Recall Bulletin 230224REV

RECALL BULLETIN: 230224REV	The purpose of this Recall Service Bulletin is to inform REV Recreation Group dealers of the need to inspect, and if necessary, replace the inside latch used on Lippert 920 and 3500 series entry doors on certain model year 2023 Fleetwood brand Bounder, Discovery, Discovery LXE, Flair, Flex, Fortis, Frontier, Frontier GTX, Pace Arrow and Southwind. Holiday Rambler brand, Admiral, Armada, Eclipse, Endeavor, Invicta, Nautica, Navigator and Vacationer. American Coach brand American Tradition. A list of affected motorhome serial numbers appears at the end of this Bulletin.
YEAR(S) AFFECTED: 2023	
PRODUCT(S) AFFECTED: <u>Fleetwood</u> Bounder Southwind Discovery Discovery LXE Flair Flex Fortis Frontier Frontier GTX Pace Arrow <u>Holiday Rambler</u> Admiral Armada Eclipse Endeavor Invicta Nautica Navigator Vacationer <u>American Coach</u> American Tradition	<p>CONDITION: On some motorhomes affected by this recall campaign, a defect has been found at the attachment point within the entry door latch supplied to Lippert. A specific attachment point was inadvertently weakened when the vendor implemented an improvement to create a more secu

Determine Correct Latch Assembly Part

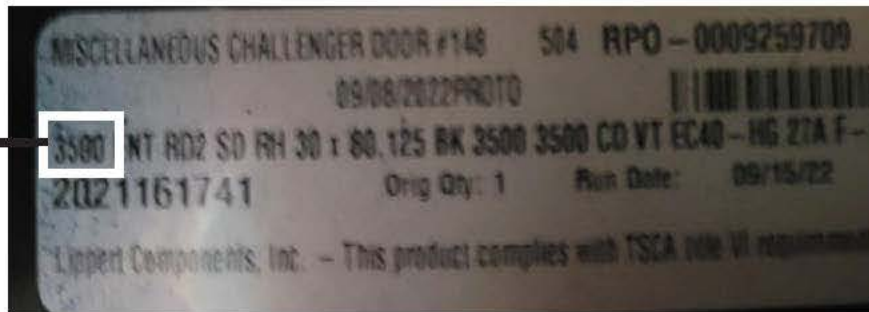
The replacement latch assembly part is determined by the serial number on the door tag. Replacement inside latch assembly for the 920 Series door is PN 2023005033. Replacement inside latch assembly for the 3500 Series door is PN 2022010407.

Fig. 5

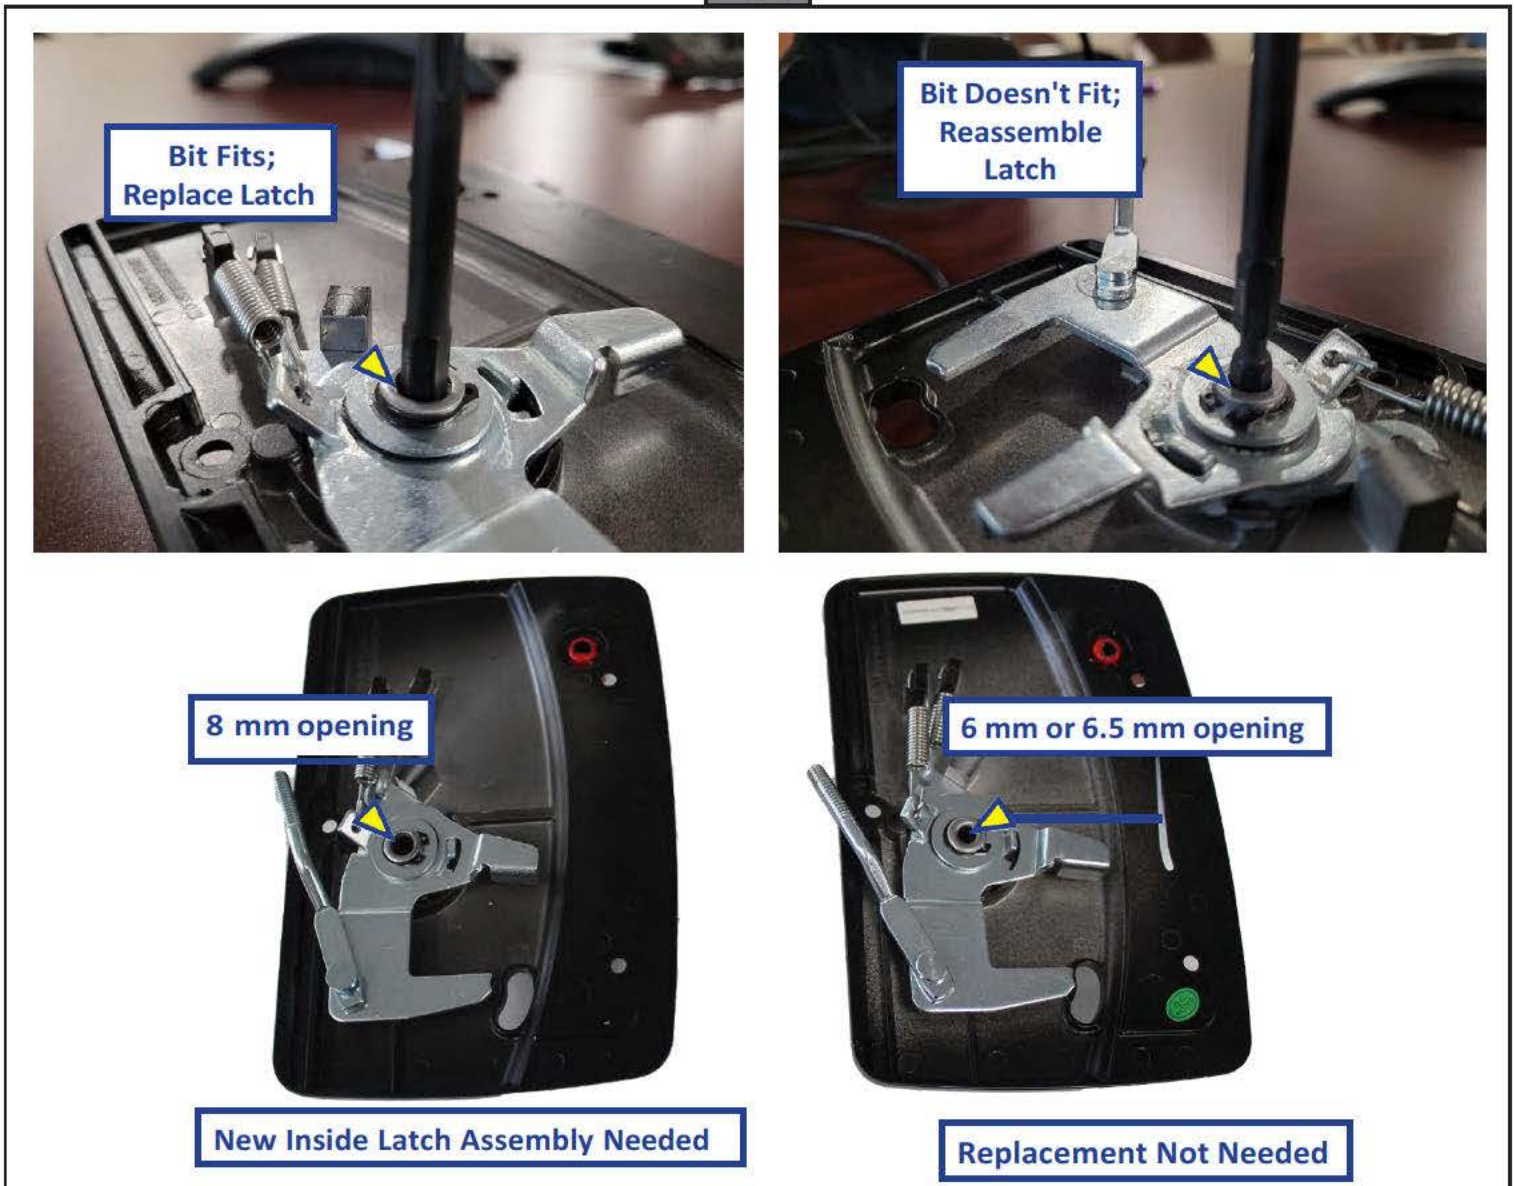
- Using a 1/4" screwgun bit, try to insert the bit into the spun rivet of the inside latch assembly (Fig. 5).
- If bit fits into rivet opening there are two options:
 - Replace the complete latch assembly, including both inside and outside latch assemblies.
 - Replace just the inside latch assembly to be combined with current outside latch assembly.
- If the bit does not fit, no action is required. Proceed to latch reassembly instructions.
